NORTHEAST UTILITIES

Millstone Nuclear Power Station, Unit No. 3
Structural and Geotechnical
Engineering Branch
Additional Information in Response
to Confirmatory Items

Attachment I

Revised Responses to Structural Audit Items:

Fig 2.3.1

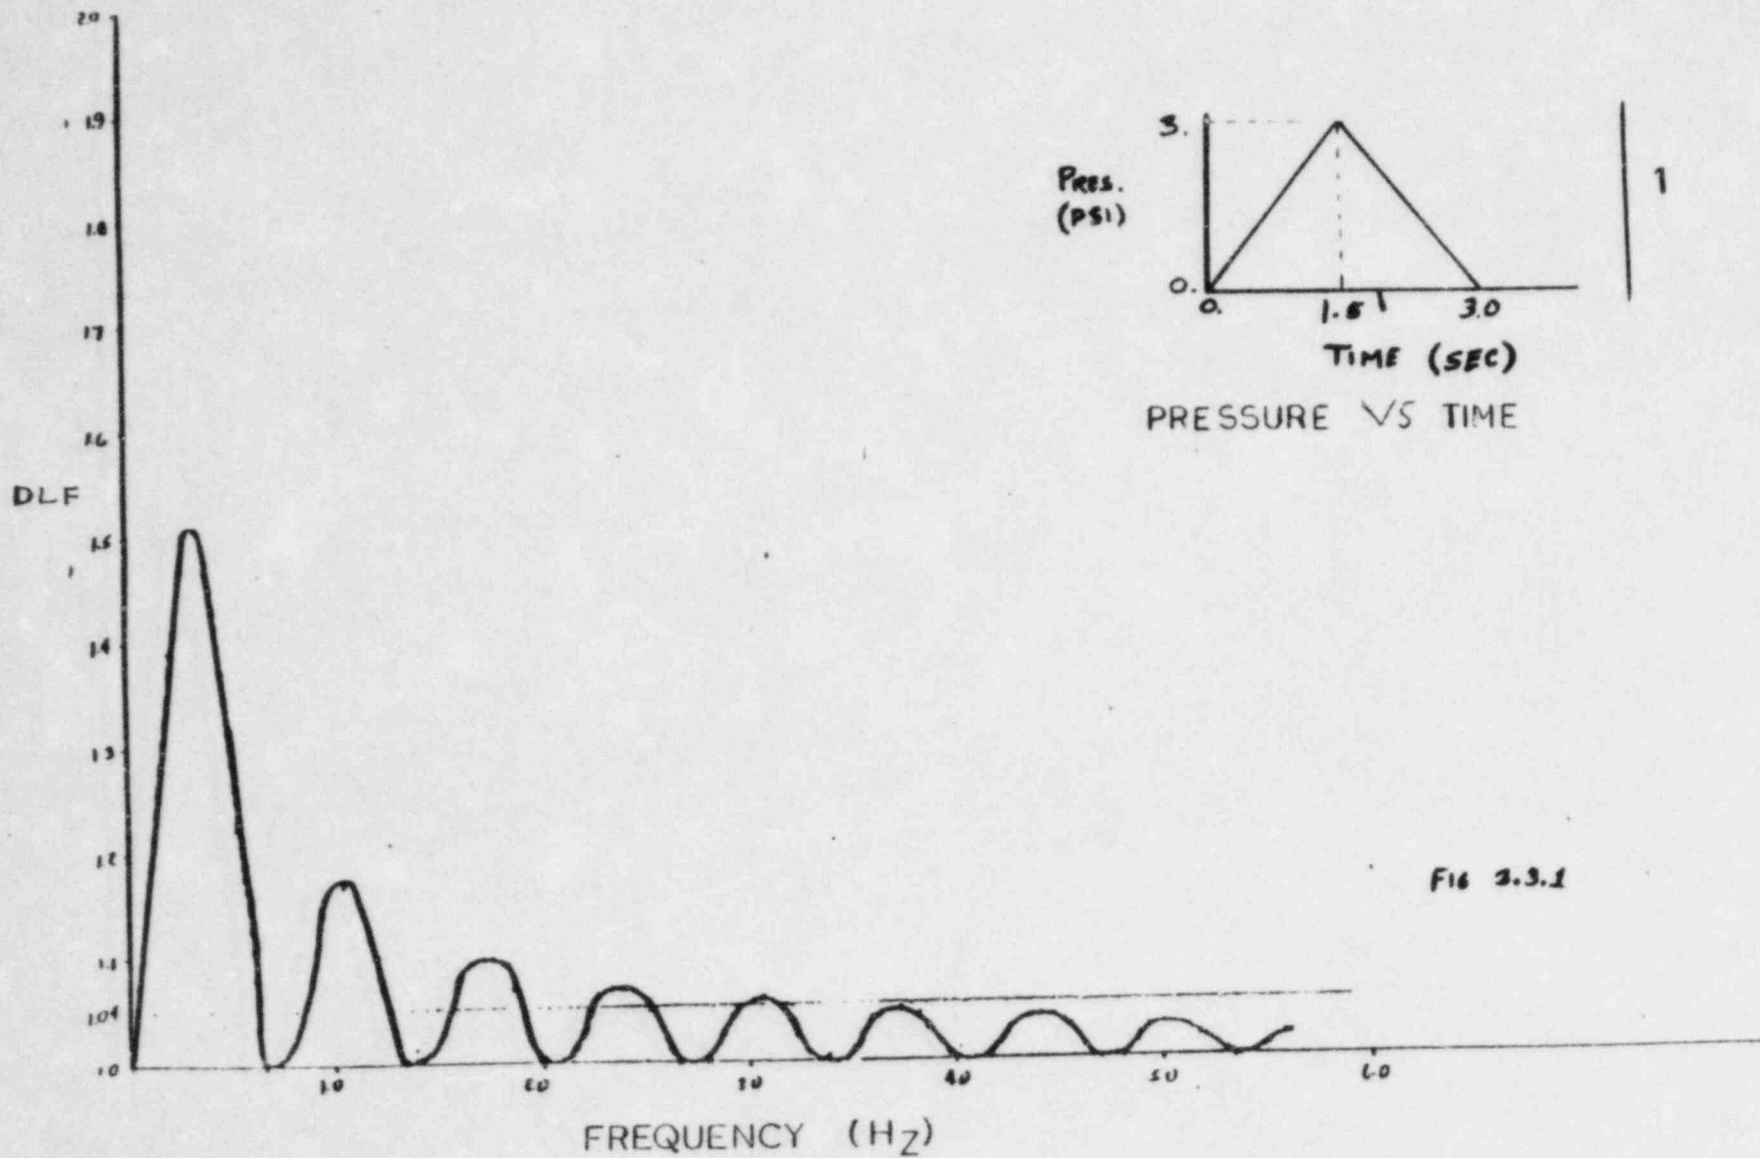
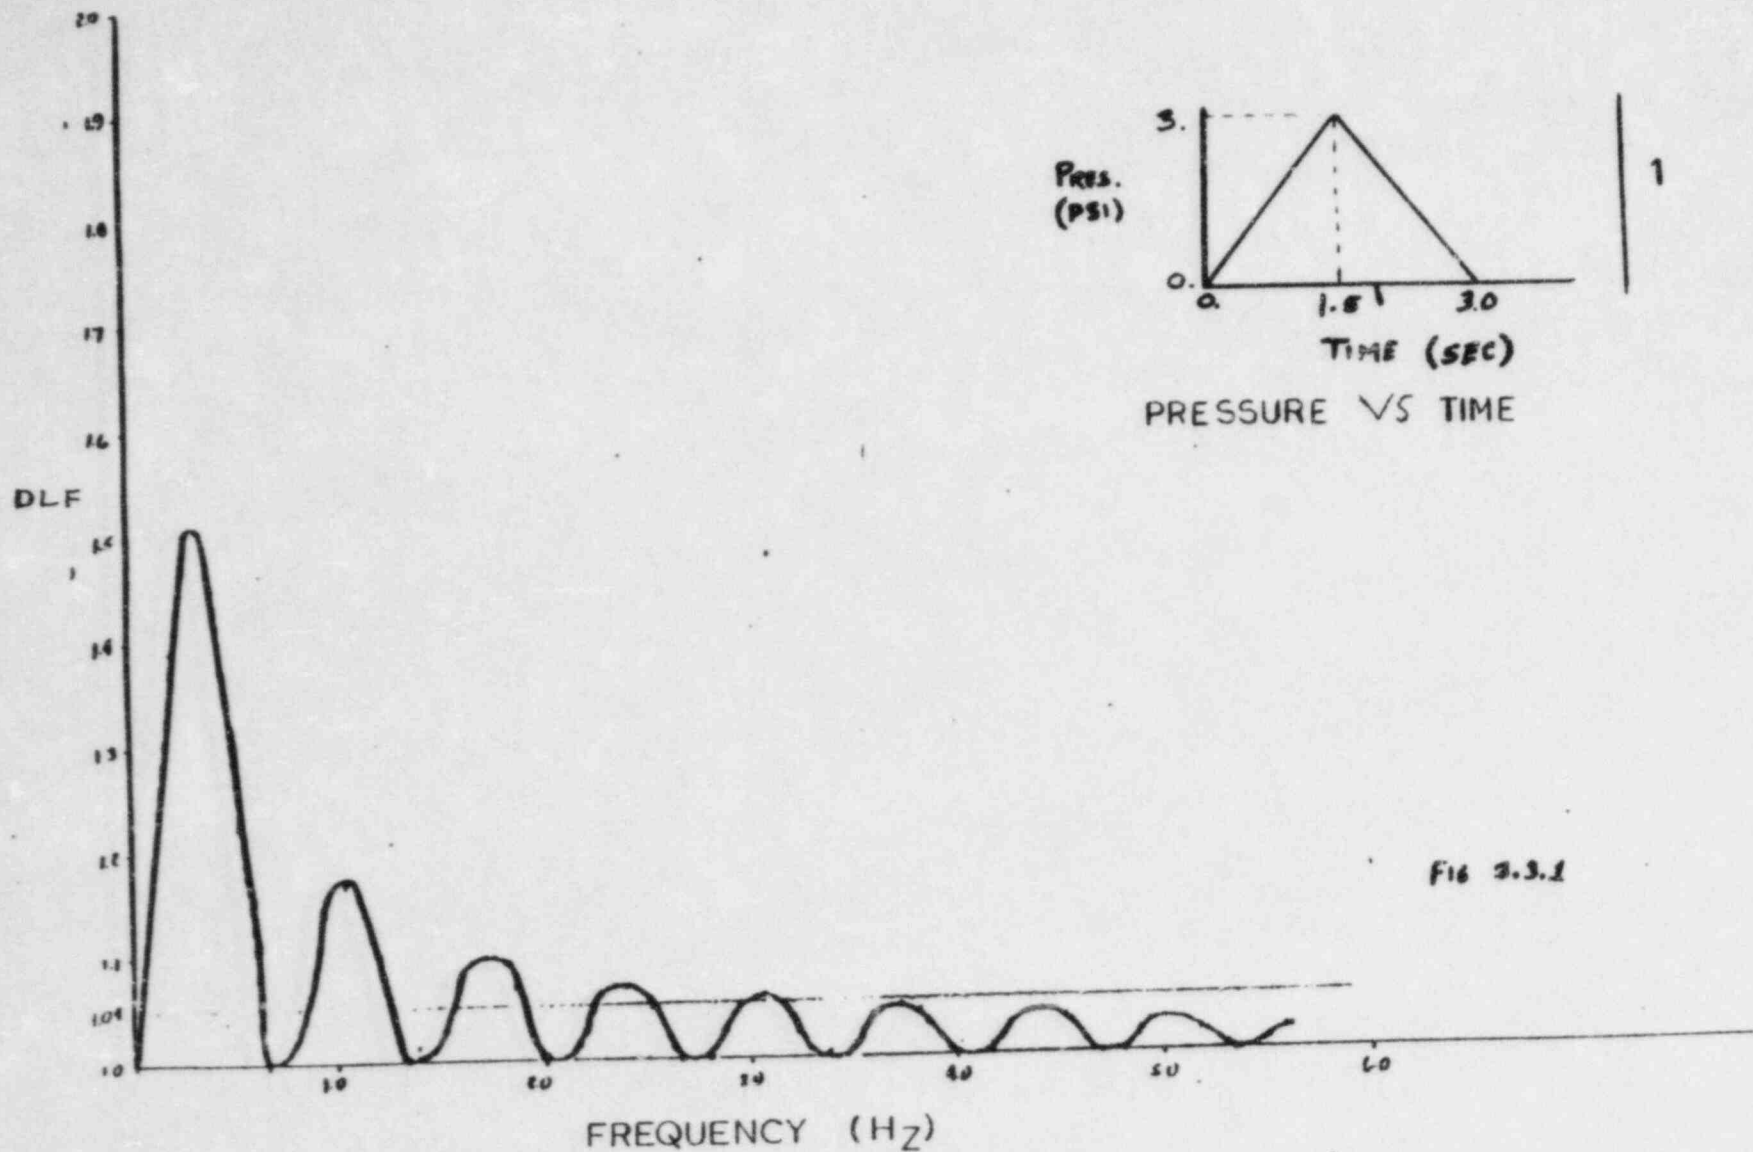
ITEM 33 Justification of unity DLF of pressure drop provided description and results as presented. Resolved. The Applicant will provide the response.

The MNPS-3 FSAR will be revised to add the following:

A dynamic load factor of 1.0 is applied to the pressure drop since all wall and floor panels subject to pressure drop have frequencies greater than 4 Hz as shown in Table 3.3.1. Figure 3.3.1 presents the pressure drop time history and the calculated dynamic load factor curve for the pressure drop. Comparing the two it is evident that the Millstone III structural elements experience no dynamic amplification during the pressure drop condition. | 1
